Form C-103
June 19, 2008

SUNDRY NOTICES AND REPORTS ON WELLS (DO NOT USE THIS FORM FOR PROPOSALS TO DRILL OR TO DEEPEN OR PLUG BACK TO A DIFFERENT RESERVOIR. USE "APPLICATION FOR PERMIT" (FORM C-101) FOR SUCH PROPOSALS.)		WELL API NO. 30-015-37588

2. Name of Operator EOG Resources, Inc.		6. State Oil & Gas Lease No.
3. Address of Operator P.O. Box 2267 Midland, TX 79702		7. Lease Name or Unit Agreement Name: Elk Wallow 11 State

EOG Resources requests the following changes be made to our approved APD and plan:

Proposed Wellbore - Original

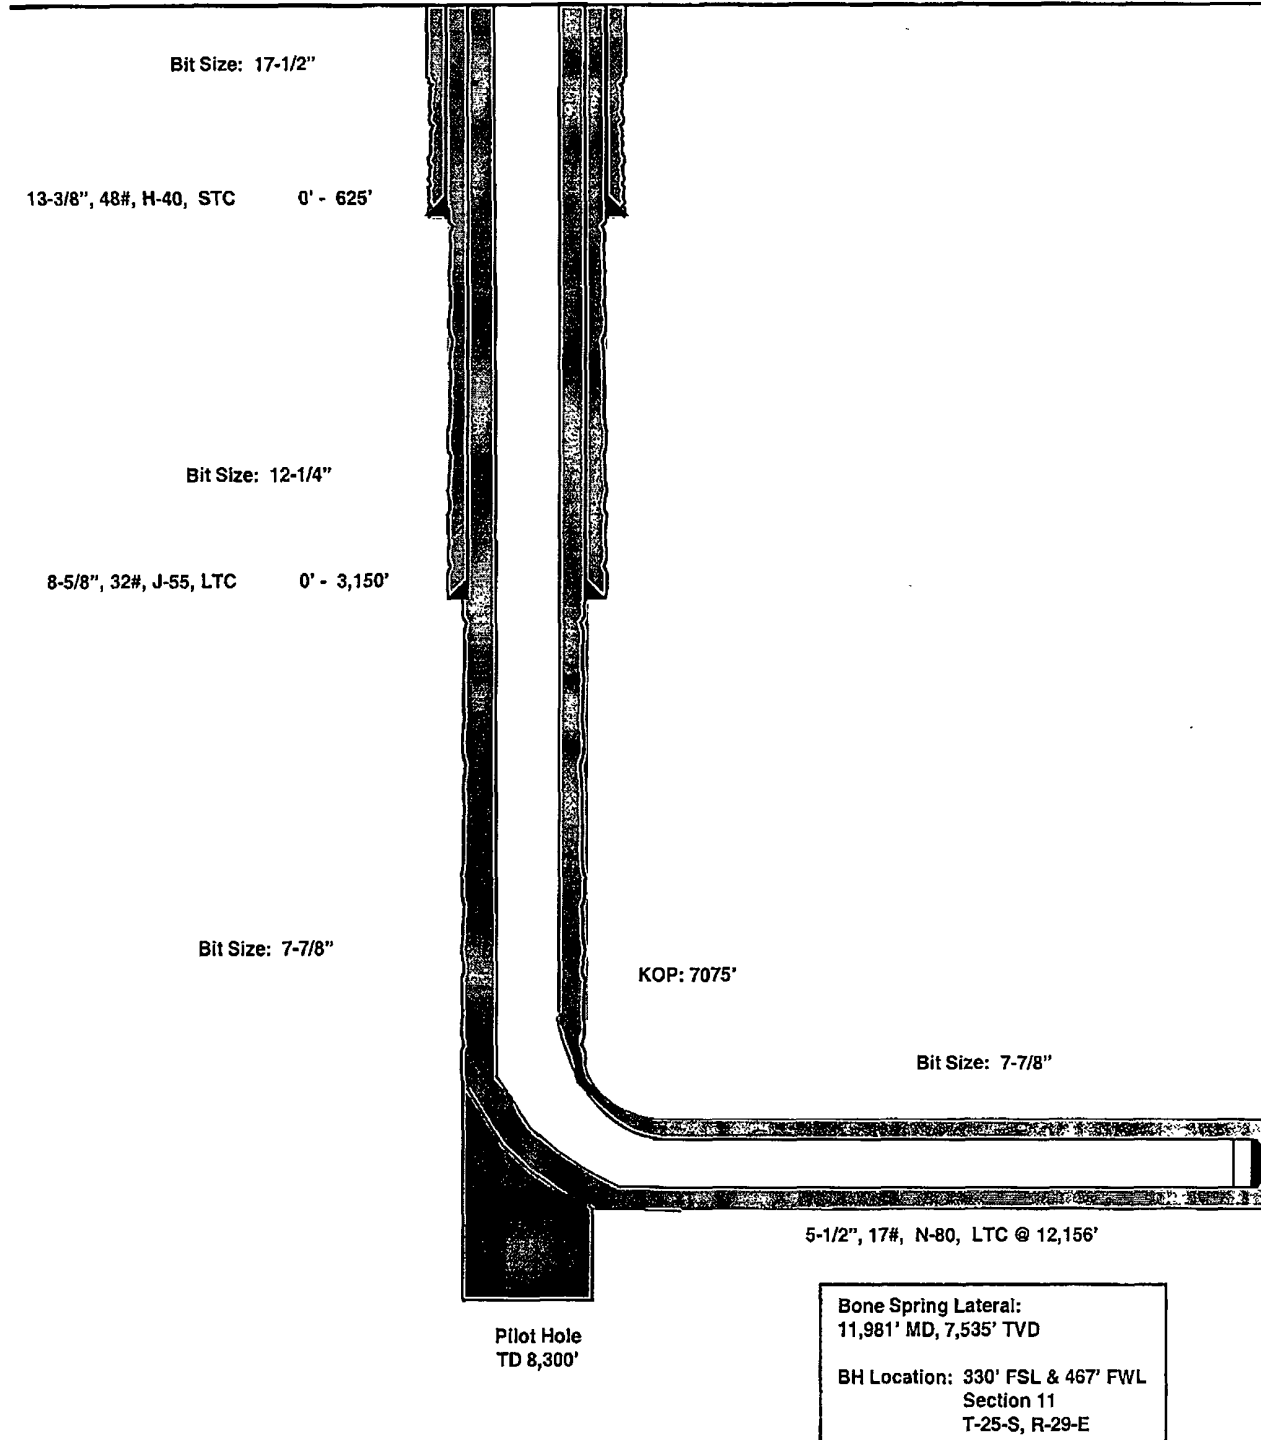
1. Change the surface casing from 13-3/8", 48#, J55 to 13-3/8", 54.5#, K55 BTC.
2. Change the production casing from 5-1/2", 17#, N80 LTC to a combination of 7", 26#, HCP110 LTC and 5-1/2", 17#, HCP110 LTC.
3. We request permission to utilize only a 13-5/8" 2000 psi annular BOP to drill from 625' to the intermediate casing point at 3150'.
4. A 3000 psi double ram BOP will be utilized from intermediate casing point at 3150' to final TD.

3rd party test required on BOP prior to drlg. out from under int. casing.
